Re: **Rising Moon Subdivision**

MDP # 014A-07

The Development Review Committee has reviewed **Rising Moon Subdivision** Master Development Plan Amendment or **M.D.P. # 014A-07** Please find enclosed a signed copy for your files. However, please note the following conditions:

RISEING MOON SUBDIVISION
MASTER DEVELOPMENT PLAN LP08-R1

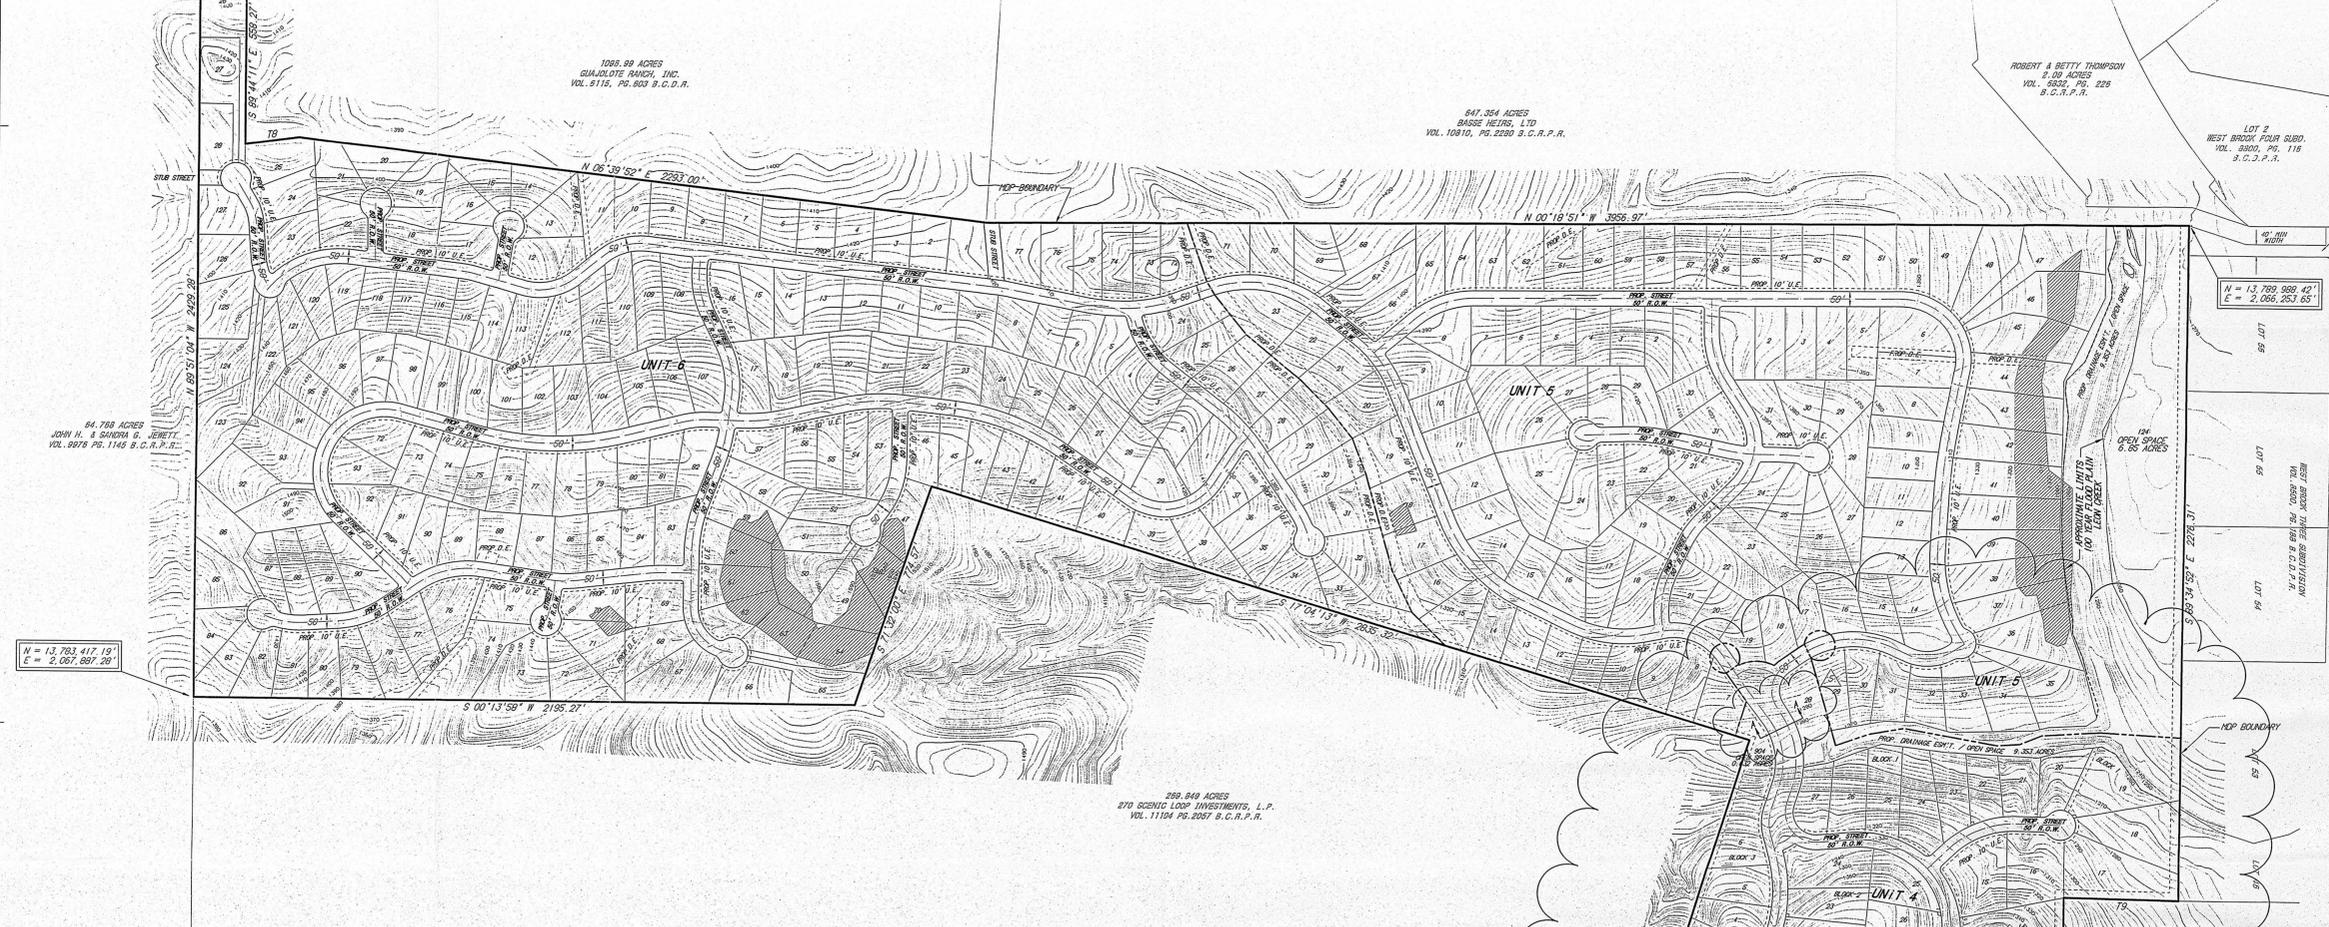
The Texas Sites Atlas indicates that archaeological sites have been previously identified nearby the above referenced property. Therefore, the property may contain sites, some of which may be significant. Thus, before any work that might affect any sites is begun we recommend that a qualified professional conduct an archaeological investigation of the property. The investigation should be performed according to Archeological Survey Standards for Texas, and previously identified sites should be reexamined and reevaluated, if any. A list of qualified professional archaeological consulting firms is available on-line at www.c-tx-arch.org. The consultant will probably need to obtain an antiquities permit from the SHPO prior to starting the investigation. A report of findings should be prepared according to the Council of Texas Archeologists [CTA] Guidelines for Cultural Resource Management Reports and submitted to the HPO and SHPO for review. Copies of the survey standards, the CTA guidelines, and a list of qualified consultants may be obtained by calling the SHPO at 512-463-6096 or writing to P.O. Box 12276, Austin, Texas 78711-2276. If part of the property was already investigated since July 12, 2007, it may be omitted and the report for the previous study may be submitted for that part. Law allows both the HPO and SHPO 30 days from receipt for reviews.

- All access roadways shall provide clear sight distance on all existing and proposed roadways in order to provide adequate obstruction free viewing distances for approaching traffic. All signage, landscaping, and improvements shall be selected and located so as to not to block these clear sight distance areas.
- The developer shall be responsible for providing right turn deceleration lane at the two proposed entrances, with storage lengths and bay taper per TXDOT design standards as it relates to the submitted TIA traffic counts, UDC 35-502(a)(7) subsection C.

- A Tree Preservation Plan is required prior to any work on site. This can be submitted either as a Master Tree permit or at the platting stage. This project appears to be suited to a Tree Stand Delineation Plan (30% preservation of tree canopy at MDP or 35% preservation at platting) based on the large lot sizes and tree canopy area. Note that floodplain area must be delineated separately (preserved at 80% for significant trees and 100 % for heritage trees).

- 100 year Flood Plain Shown and Buffering (if applicable)
- Sensitive Recharge Features and Buffering (if applicable)
- Category Letter for All Site Specific Plats (if Category 2 or 3, an Aquifer Protection Plan is required)
- A Water Pollution Abatement Plan or Contributing Zone Plan must be submitted to and approved by the Texas Commission on Environmental Quality (TCEQ) prior to construction.
- According to the CZ Plan (SAWS # 1583) and the Aquifer Protection Ordinance #81491 Sections 34-914 buffering may be required. In some places up to 100 feet. Any existing

- Right-turn deceleration lanes will be required on Scenic Loop Road for both proposed access points through separate permit by Bexar County. UDC 35-502(a)(7)(D)
- Secondary access must be constructed with or prior to the approval of any plat or combination of plats exceeding 125 dwelling units as per UDC 35-506(e) (7).
- Traffic controls shall be warranted as per the Texas Manual on Uniform Traffic Control Devices and approved by Bexar County.
- Residential lots shall not side against Scenic Loop Road, which is classified as a Secondary Arterial Type A roadway.

- That the developer commits to incorporate dark sky lighting measures (such as the July 22nd, 2008 Bexar County light order or proposed City of San Antonio equivalent). Contact Andrew Winter with Bexar County at (awinter@bexar.org) or 210-335-6487 for additional information on the Dark Sky ordinance adopted by Bexar County.
- Has appropriate documentation - recent surveys (not older than three (3) years conducted by a professional biological consultant IAW USFWS protocols showing that no endangered species are present and sends the surveys to USFWS Ecological Services Office in Austin. Contact Allison Arnold with U.S. Fish and Wildlife at (allison_arnold@fws.gov) or 512-490-0057 ext. 242 for additional information concerning the survey requirements.
